UNITED STATES PATENT AND TRADEMARK OFFICE

APPLICATION NO.	FILING DATE	FIRST NAMED INVENTOR	ATTORNEY DOCKET NO.	CONFIRMATION NO.
10/814,427	03/31/2004	Craig I. Walker	2936.WSG.PT	5711
26986	7590	07/27/2006	EXAMINER	
MORRIS O'BRYANT COMPAGNI, P.C. 136 SOUTH MAIN STREET SUITE 700 SALT LAKE CITY, UT 84101			NGUYEN, NINH H	
			ART UNIT	PAPER NUMBER
			3745

Office Action Summary

DETAILED ACTION

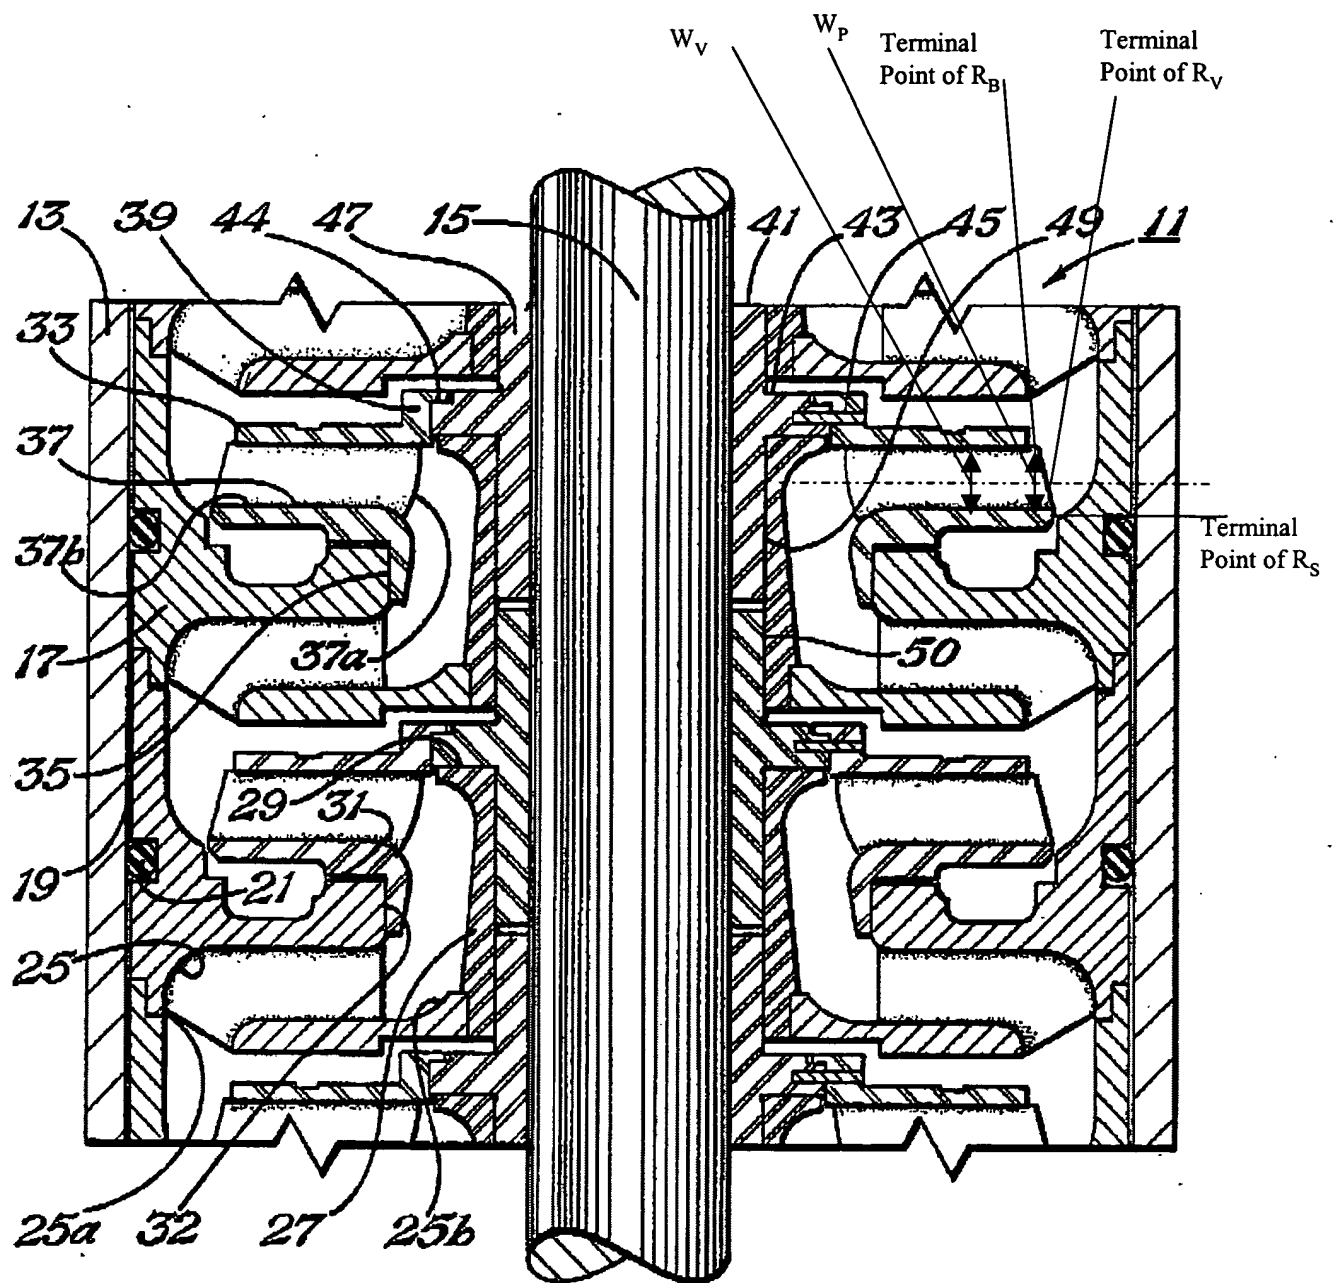
James discloses an impeller (Fig. 1) comprising at least one vane (having leading edge 37a) extending radially in length from near a central axis of the impeller to an outer peripheral edge of the impeller and having a centerline extending along the radial length which is perpendicular to the central axis of the impeller (see marked up Fig. 1 at the end of this Office Action) and the at least one vane having an outer terminal end at or near the peripheral edge of the impeller, the outer terminal end having an outwardly extending portion being convex-like shape;

wherein the outwardly extending portion has a terminus and a radius R_v (see marked up Fig.1) measured from the central axis of the impeller to the terminus, and wherein the shroud has a radius R_s , measured from the central axis to the peripheral edge, wherein R_v is equal R_s ;

wherein the outer terminal end of the at least one vane further comprises a portion having a radius R_B , where R_B is less than R_s (see marked up Fig. 1)

wherein the at least one vane A has a width W_v (see marked up Fig. 1) and wherein the outwardly extending portion has a width W_p where W_p is equal to W_v ;

wherein the at least one shroud has a radius R_s measured from the central axis to the peripheral edge, and wherein the outwardly extending portion has a terminus and a radius R_v measured from the central axis of the impeller to the terminus and the outwardly extending portion has axial ends defining a radius R_B measured from the at least one axial end to the central axis, wherein R_B is less than R_v and R_s , and R_v is less than R_s (see markup Fig. 1).

Fig. 1

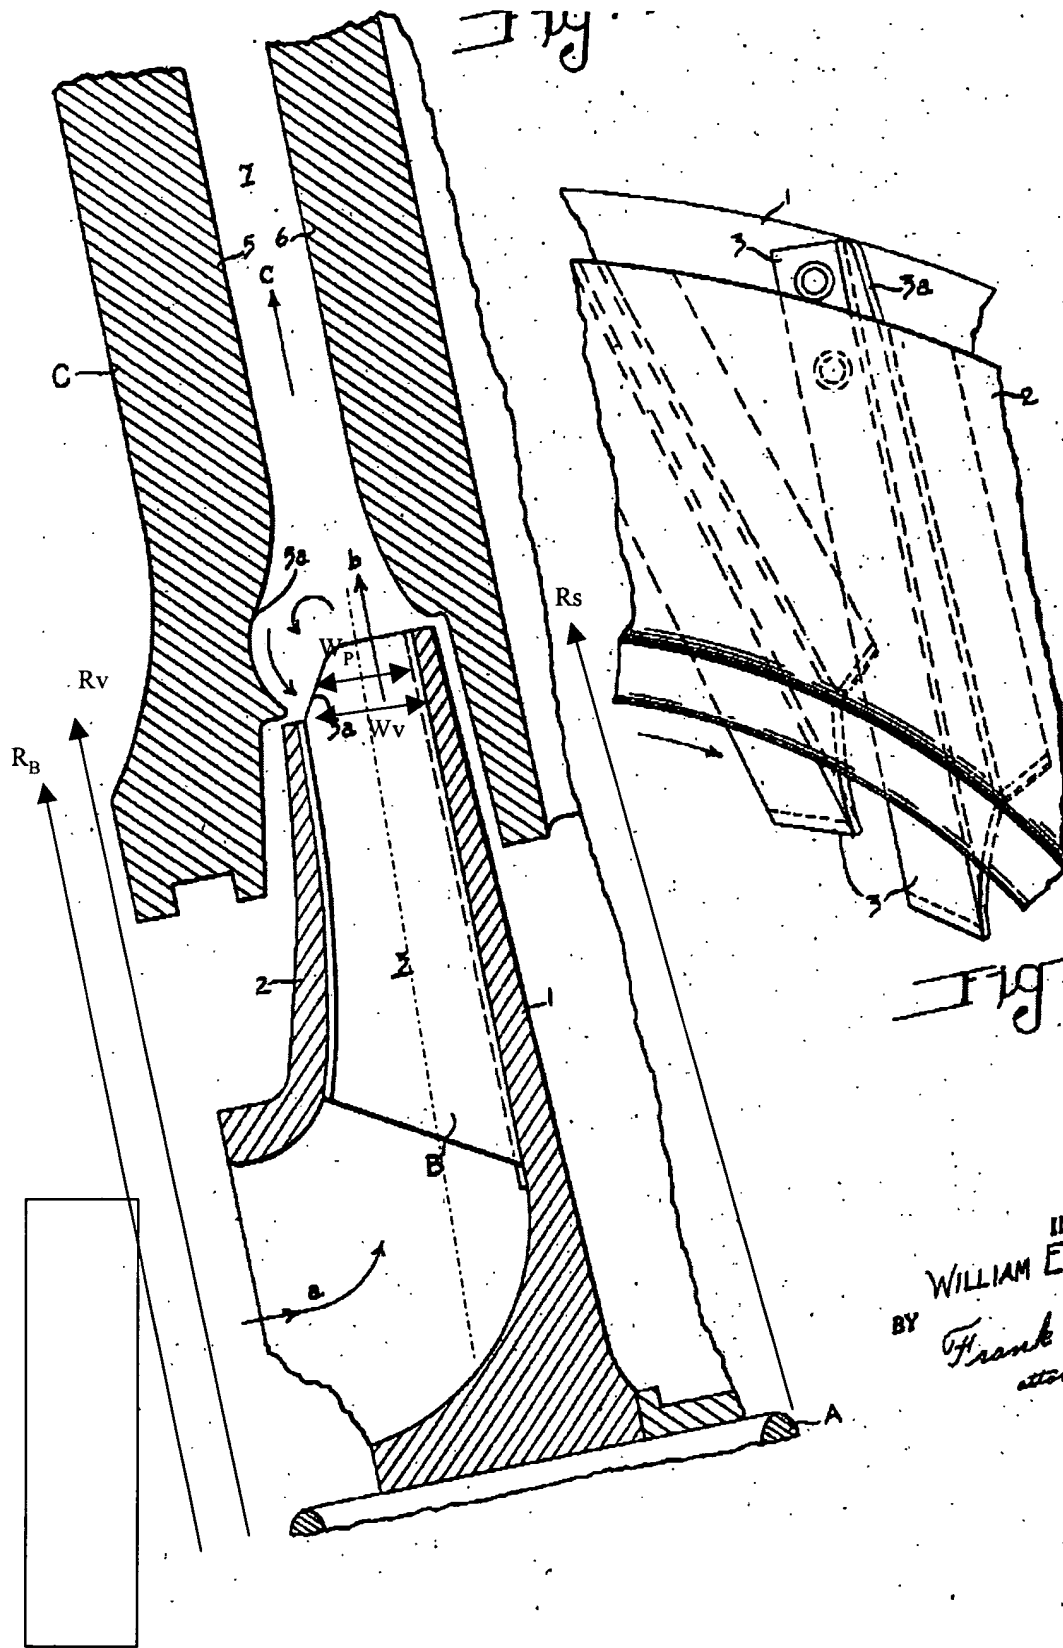
Trumpler discloses an impeller (Figs. 1, 2) comprising at least one vane 3 extending radially in length from near a central axis of the impeller to an outer peripheral edge of the impeller and having a centerline extending along the radial length which is perpendicular to the central axis of the impeller (see marked up Fig. 1 at the end of this Office Action) and the at least one vane having an outer terminal end at or near the peripheral edge of the impeller, the outer terminal end having an outwardly extending portion being convex-like shape (edge 3a);

wherein the outwardly extending portion has a terminus and a radius R_v (see marked up Fig.1) measured from the central axis of the impeller to the terminus, and wherein the shroud has a radius R_s , measured from the central axis to the peripheral edge, wherein R_v is greater than R_s ;

wherein the outer terminal end of the at least one vane further comprises a portion having a radius R_B where R_B is equal to R_s (see marked up Fig. 1);

wherein the at least one vane A has a width W_v (see marked up Fig. 1) and wherein the outwardly extending portion has a width W_p where W_p is less than or equal to W_v .
